SUBJECT: PALO VERDE NUCLEAR GENERATING STATION, UNITS 1, 2, AND 3 - NRC
AUGMENTED INSPECTION TEAM (AIT) REPORT 05000528/2004012;
05000529/200412; 05000530/2004012

Report No.: 05000528/2004012; 05000529/2004012; 05000530/2004012

Facility: Palo Verde Nuclear Generating Station, Units 1, 2, and 3

ATTACHMENT 7

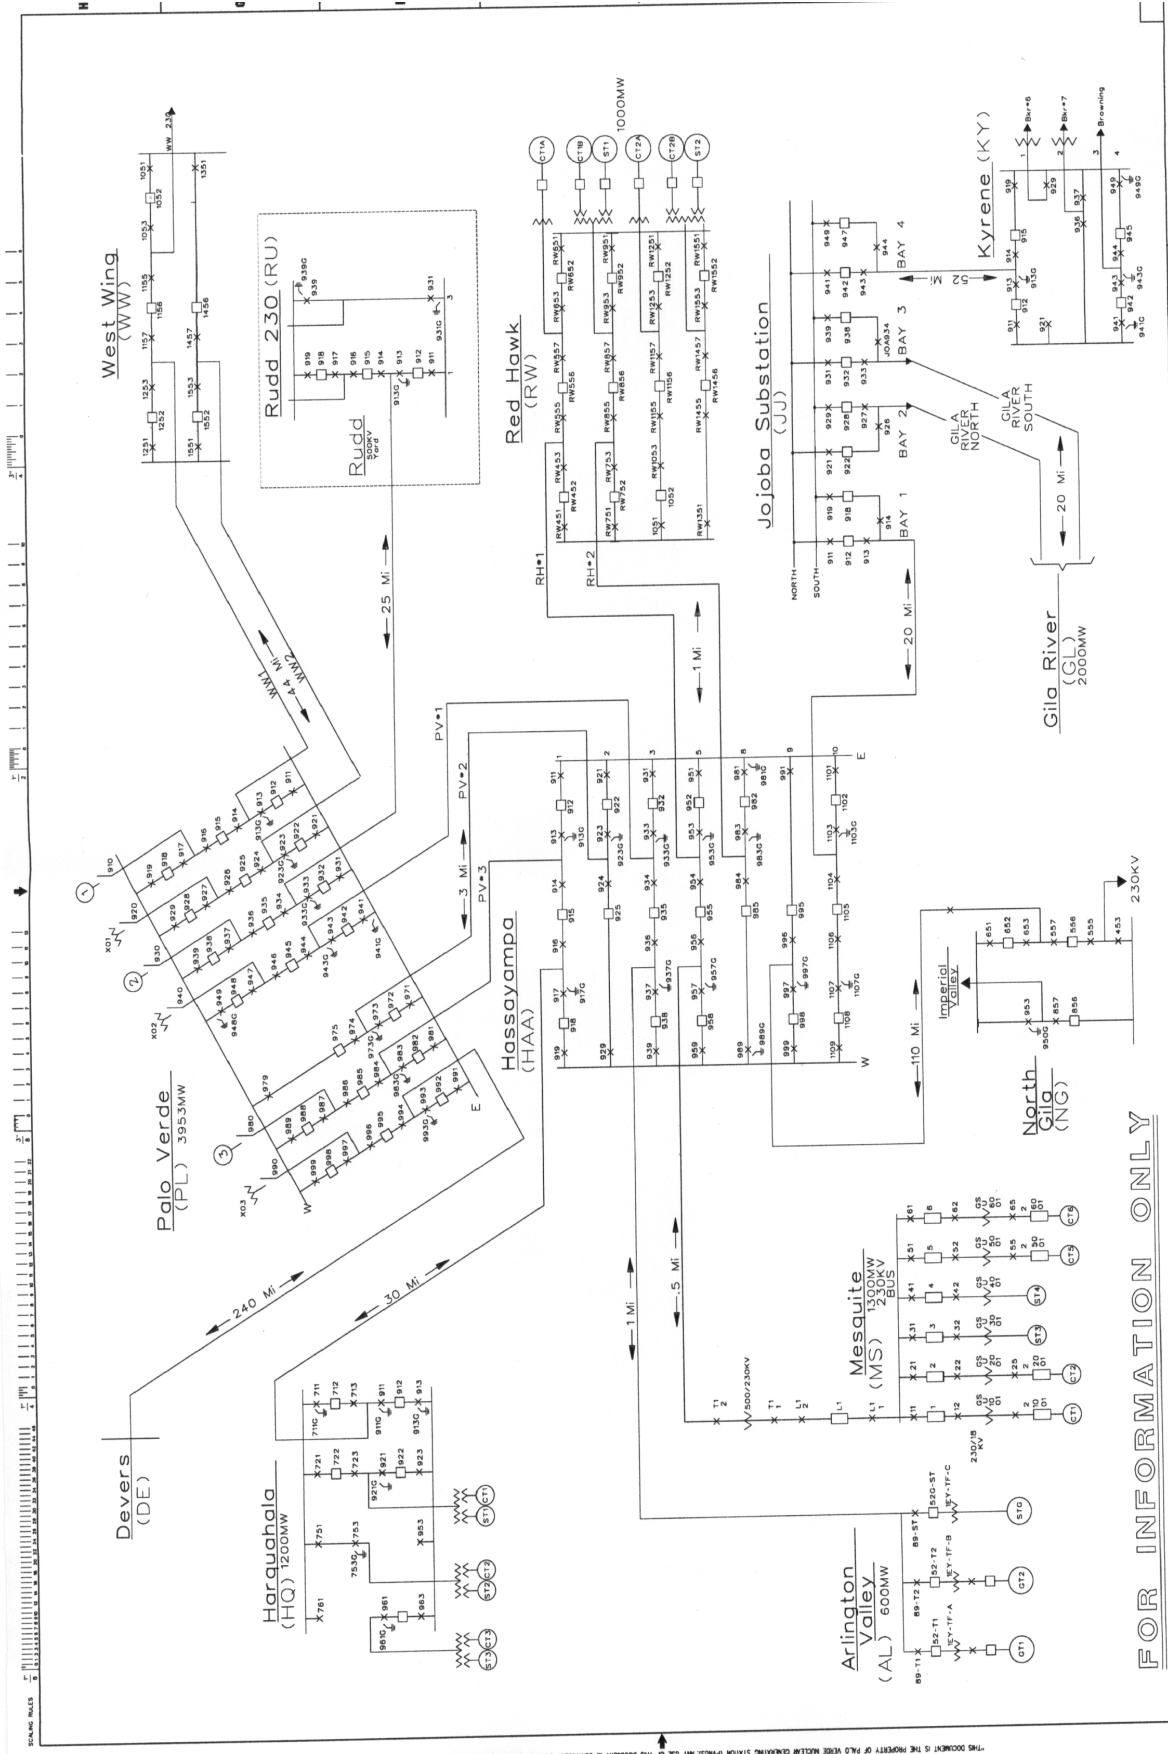
The PVNGS is connected by its associated transmission system to the Arizona-New Mexico-California-Southern Nevada high voltage grid, which is interconnected to other high voltage systems within the Western System Coordinating Council (WSCC). Attachment 7 contains a drawing of the local PVNGS grid arrangement.
